## Addendum #01

Project Name: West Campus Chilled Water Loop  
Facility Name: Arkansas Tech University  
Russellville, Arkansas

Insight Project Number: 24-006  
Date: 11/22/2024

## 1 WEST LOOP CHILLED WATER CONTROL DIAGRAM

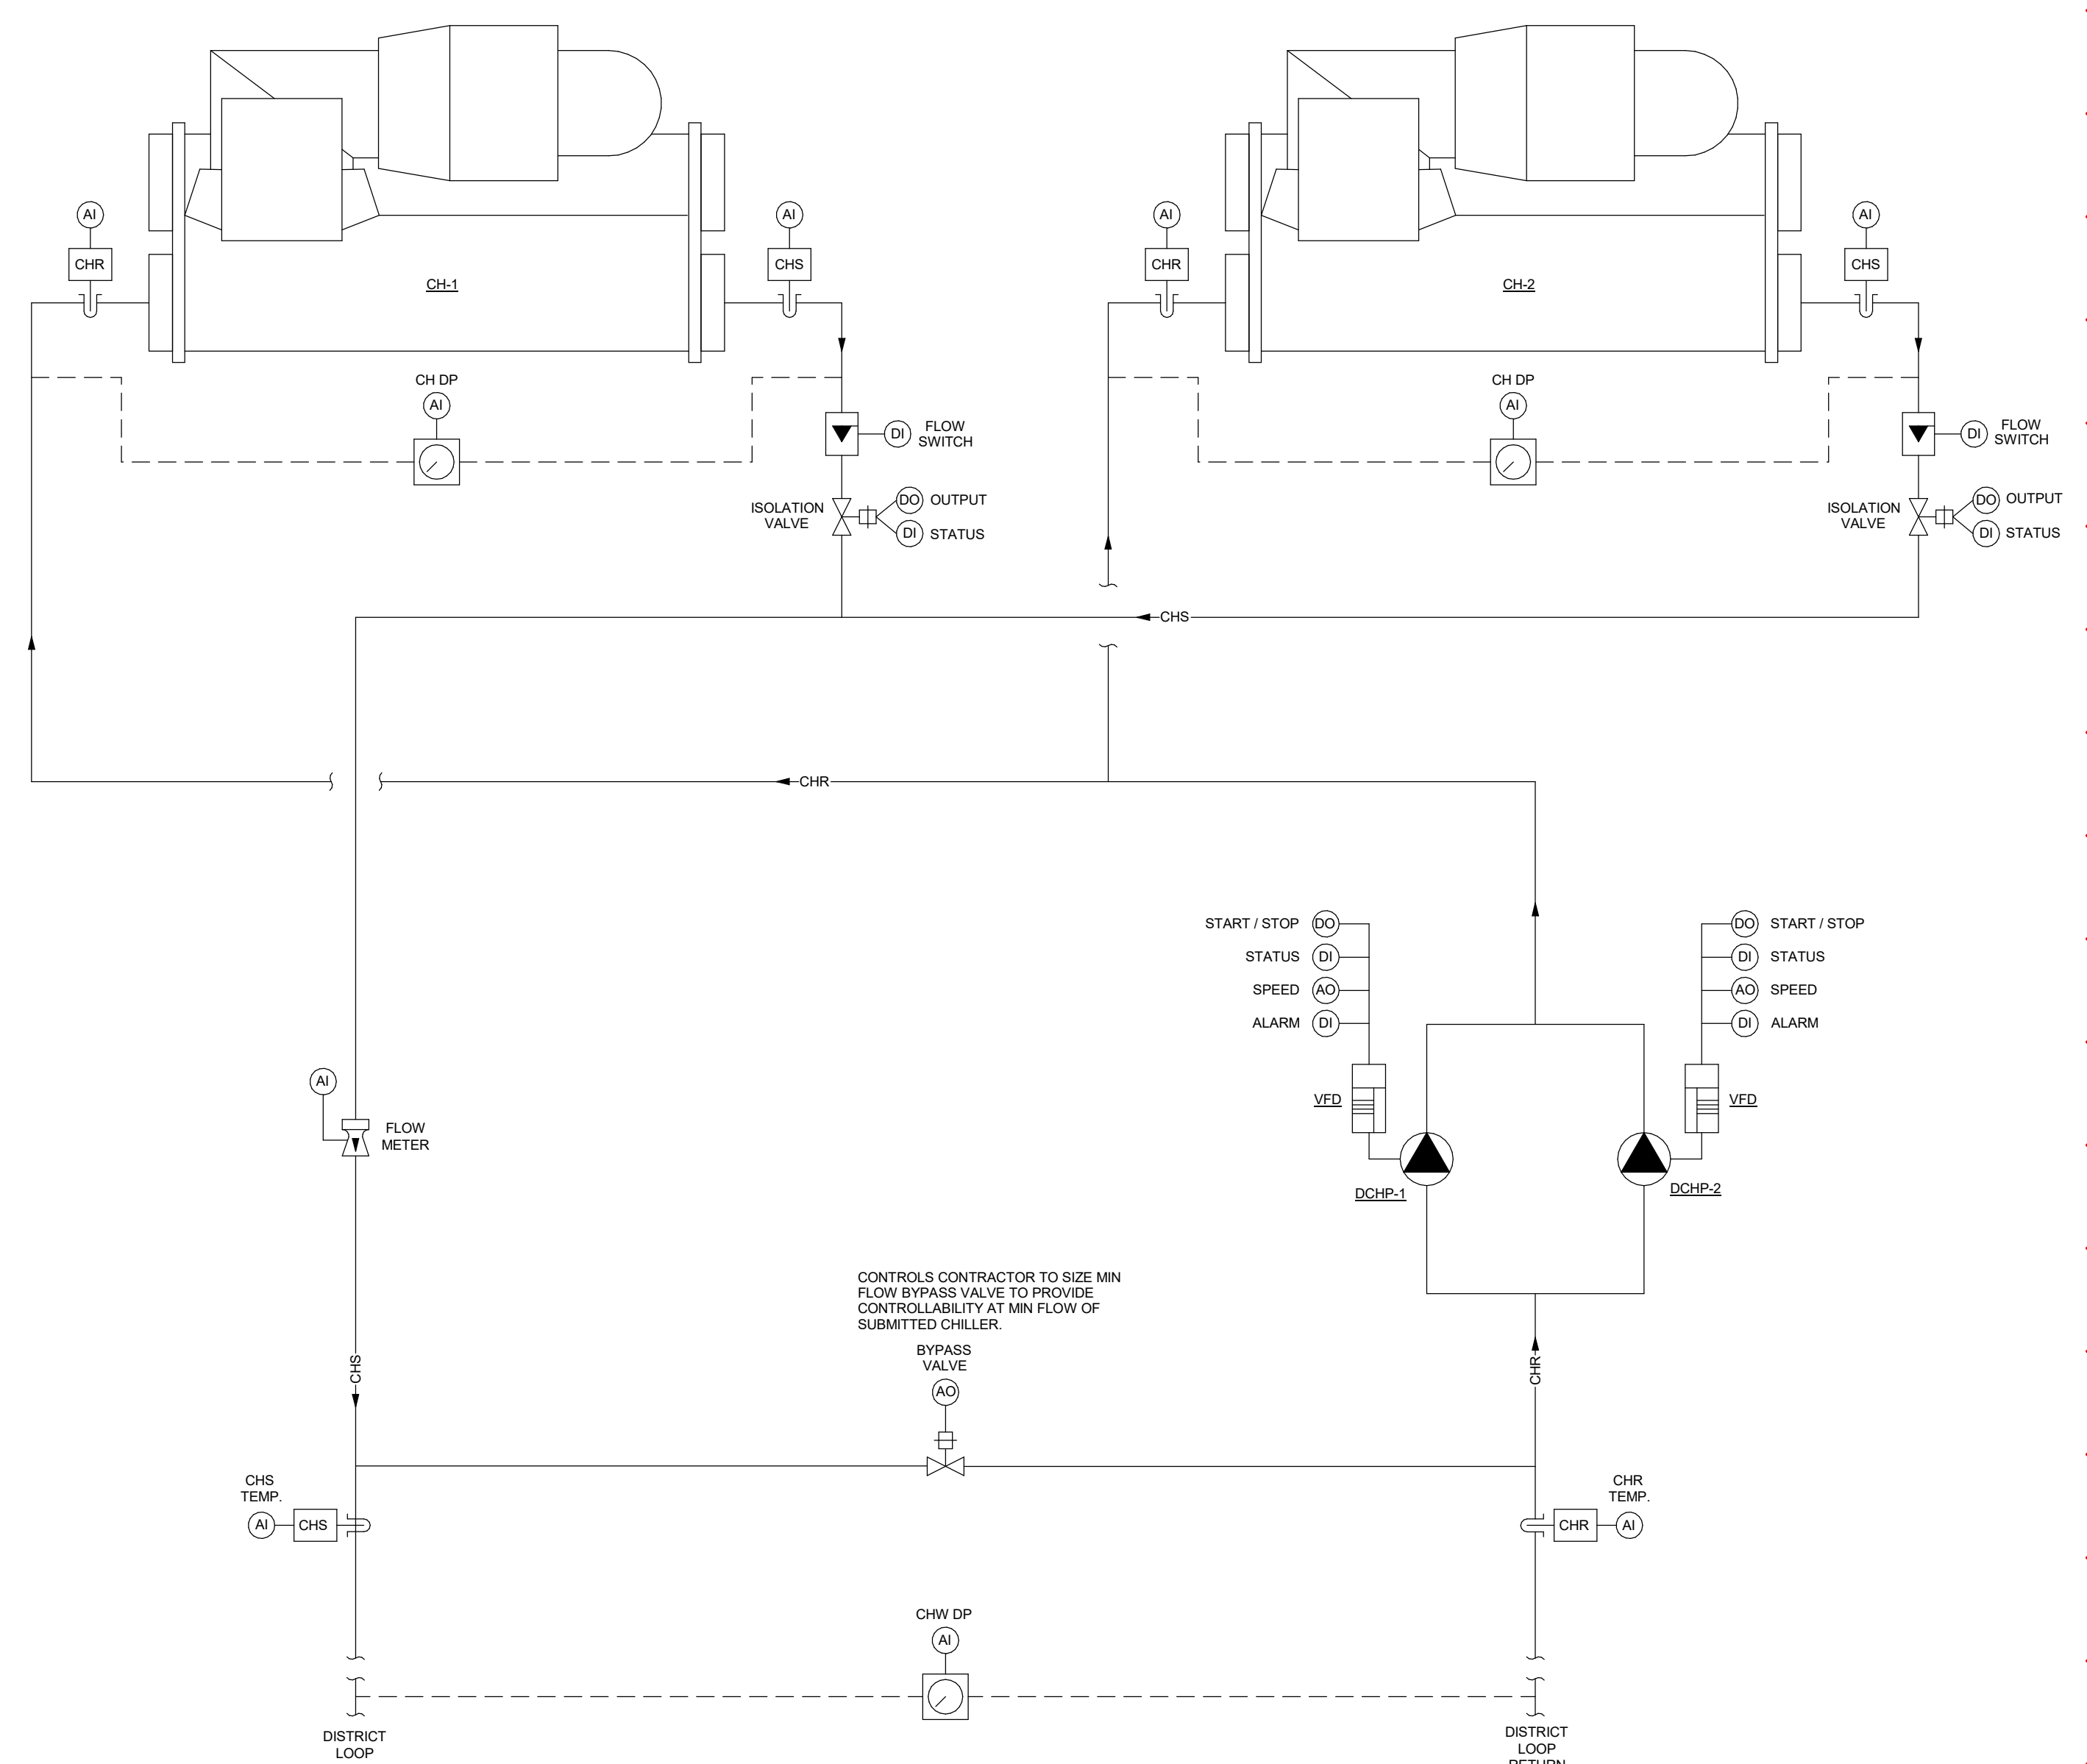
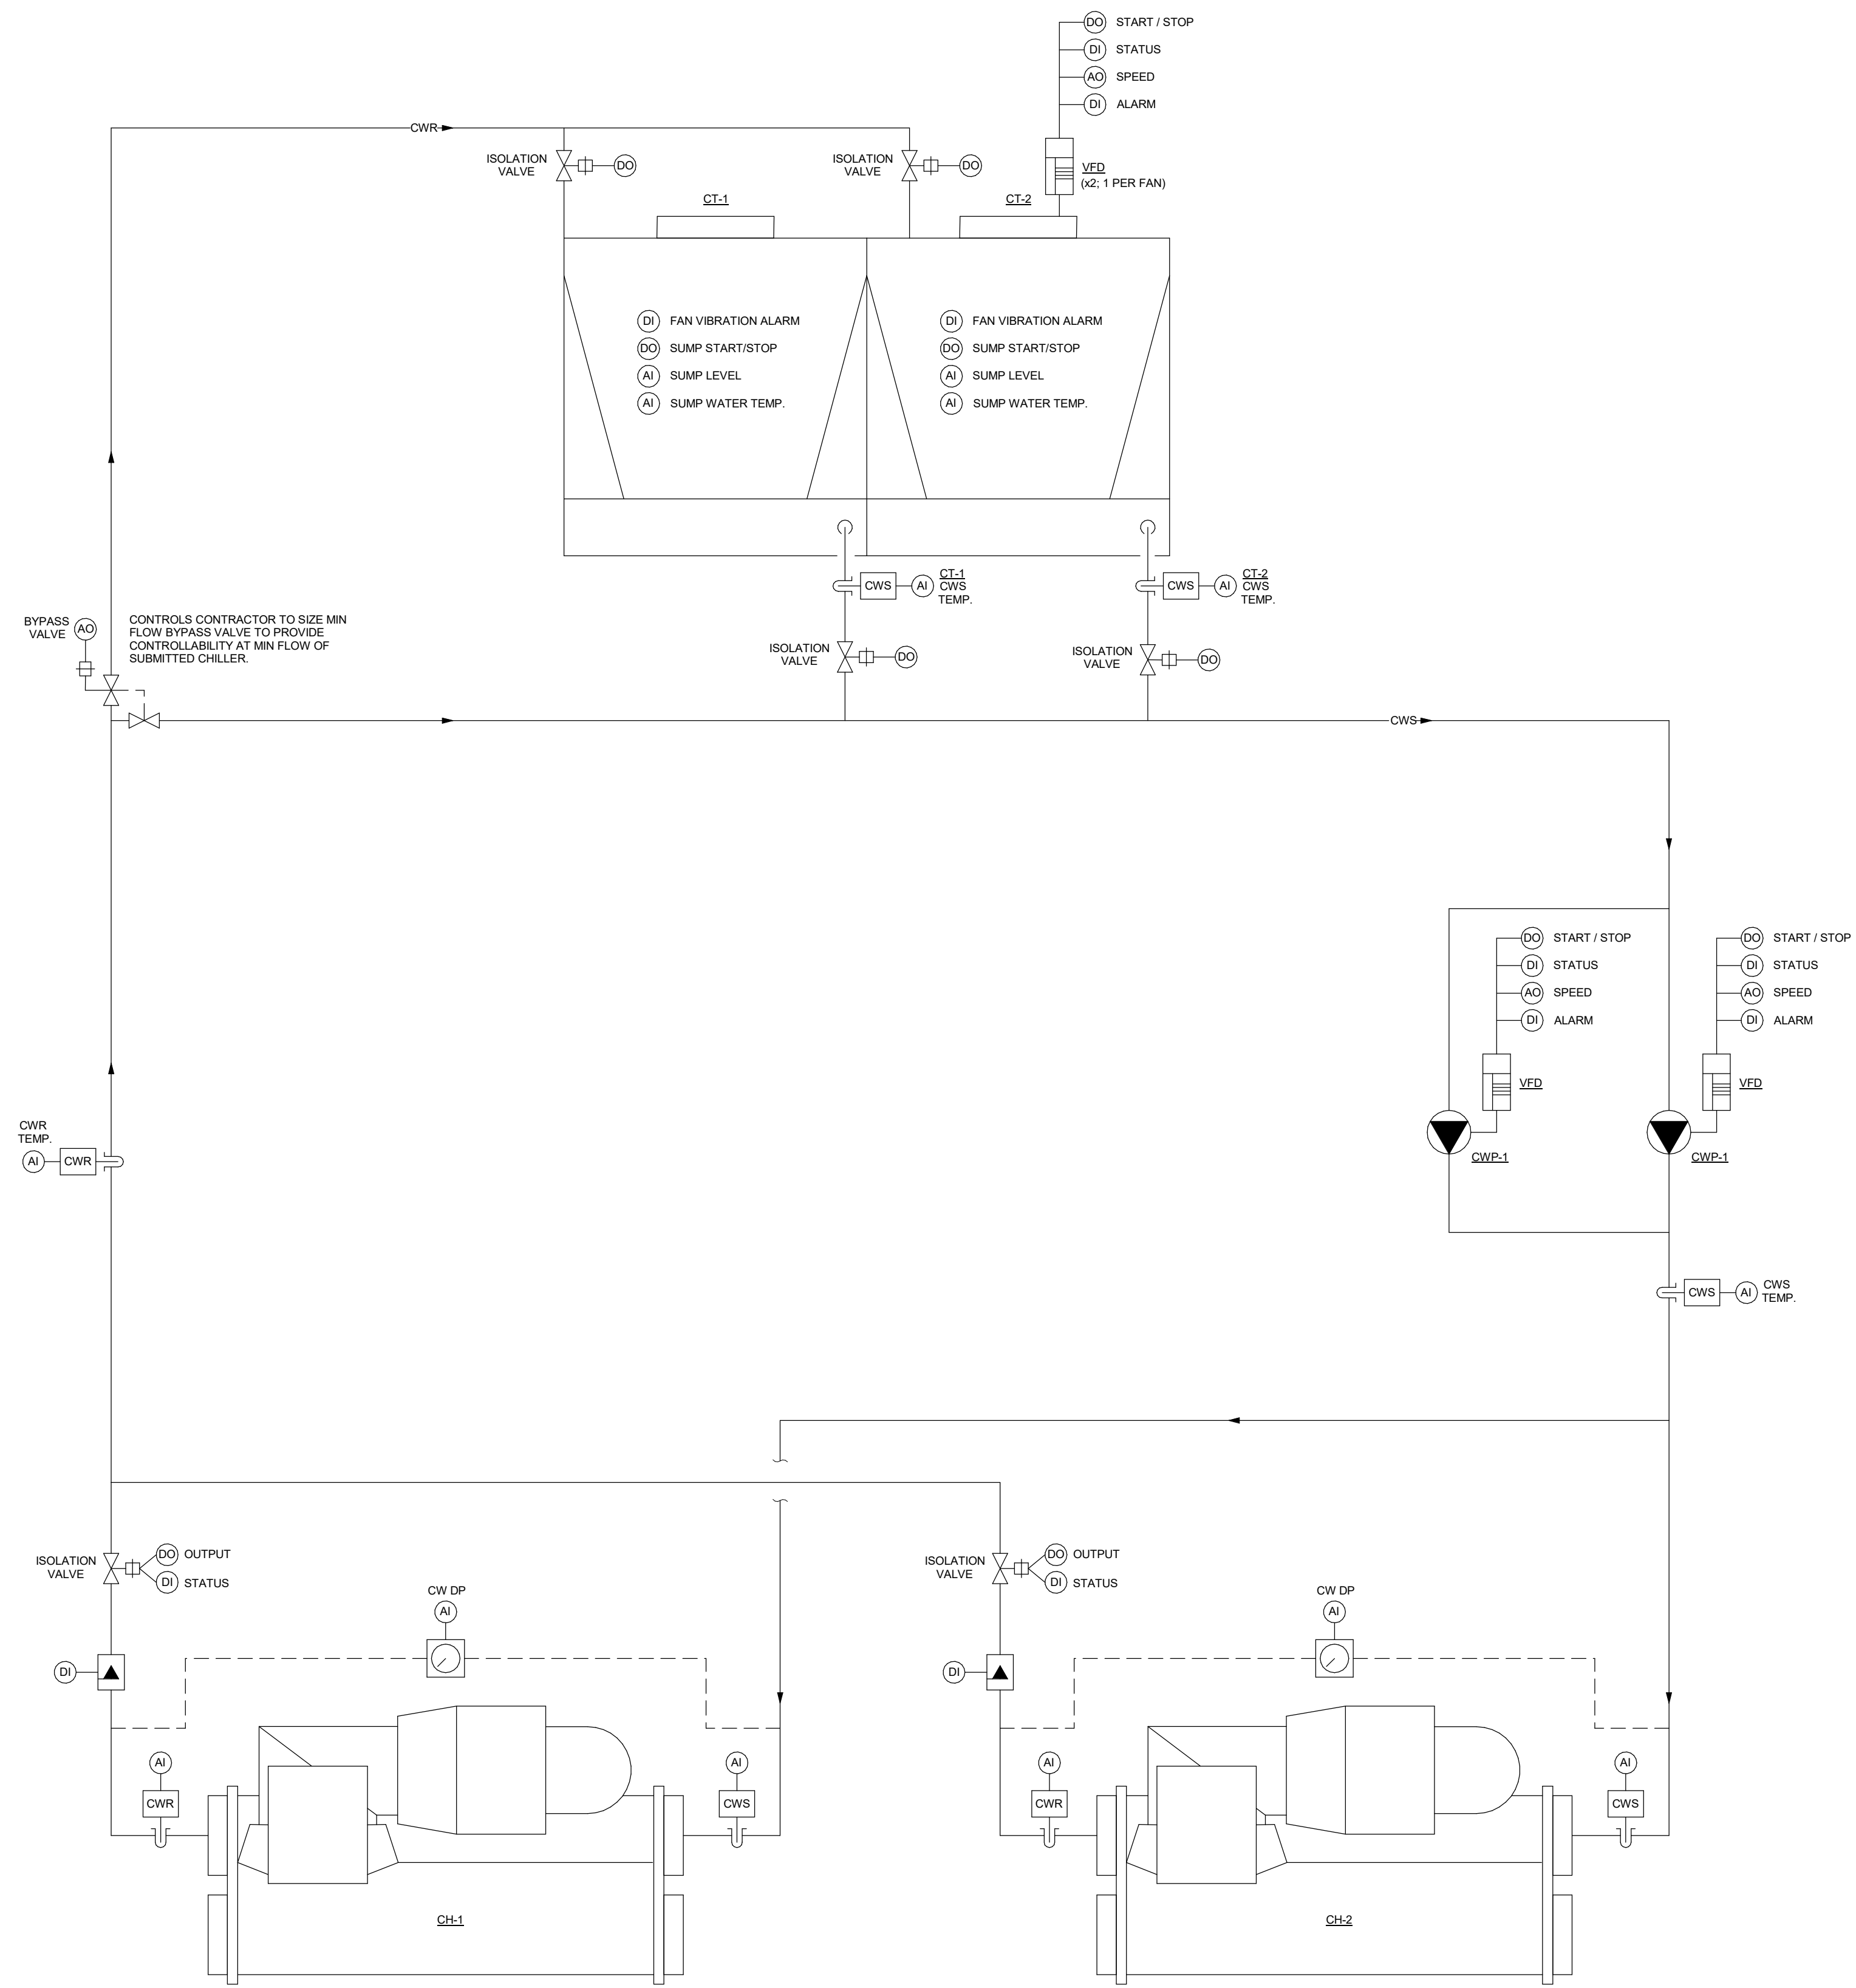
4. Refer to Sheet M401 – MECHANICAL SCHEDULES
  - A. Edited Pumps schedule notes.
5. Refer to Sheet M502 – MECHANICAL CONTROLS WEST LOOP
  - A. Edited piping diagrams to include notes about the bypass valves.
